To: Brent Damman - Zoning Administrator
From: Adam C. Hoff, P.E. - City Engineer *ACH*
cc: Jeff Marihugh, Jerome Monaco
Date: March 27, 2000
Subject: Mel Lanzer Co. Office Addition

STORM WATER RUN-OFF CALC. FOR THE PROPOSED ADDITION TO
MEL LANZER CO. OFFICE BLDG.

To Tom Zgela - Mel Lanzer Co.
Fax No. (419) 599-2861
From Adam C. Hoff, P.E. - City Engineer *A.C.H.*
Date 5/5/00
Subject Fire Line
Pages 1, including this one

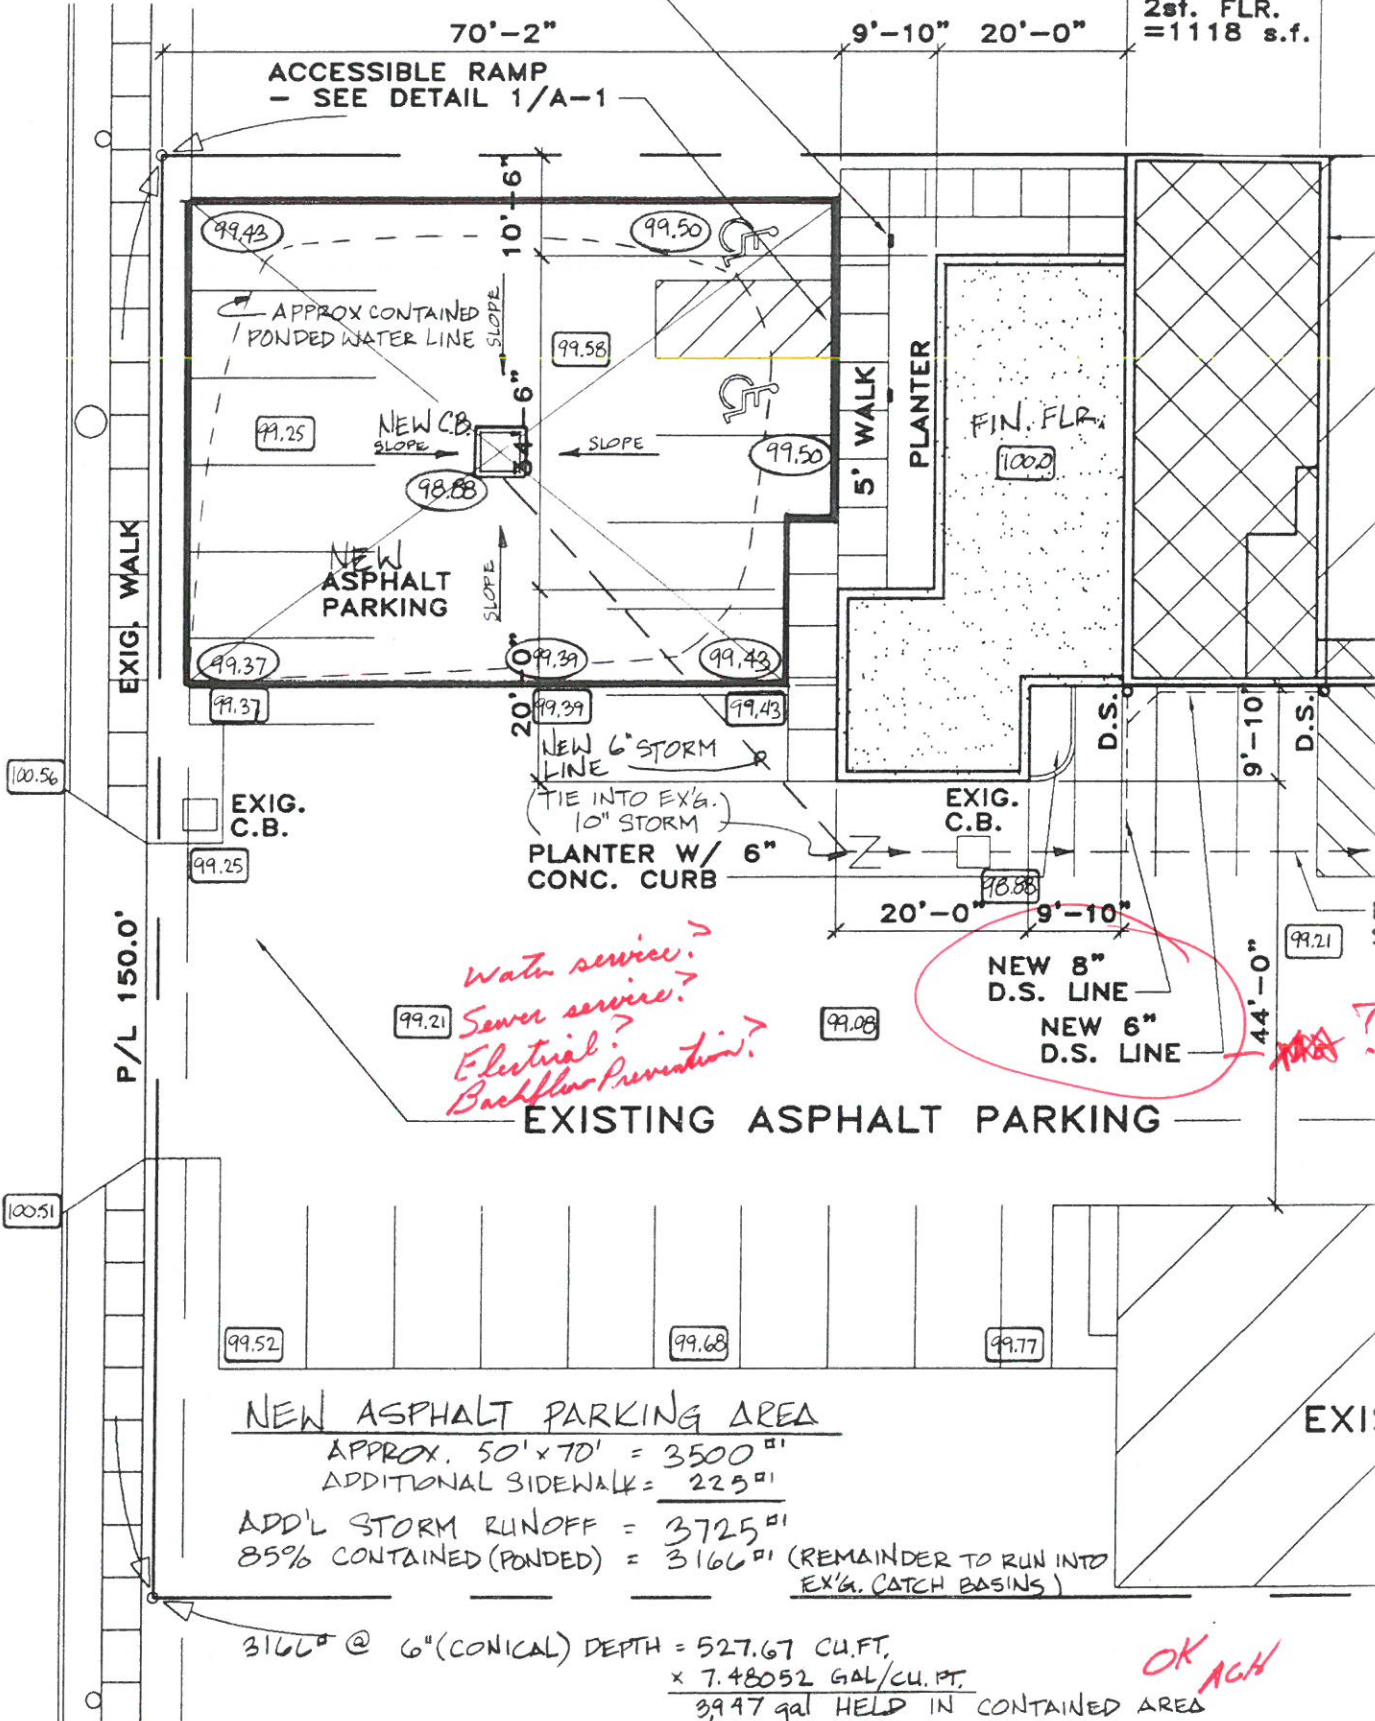
1. The stormwater detention plan is acceptable.
2. What is the proposed plan for the water, sanitary sewer and electrical service connections? Also, a backflow prevention device will need to be added to the water system, if not currently in place.
3. If not already paid, a \$25.00 plan review fee is required.

OK ACH
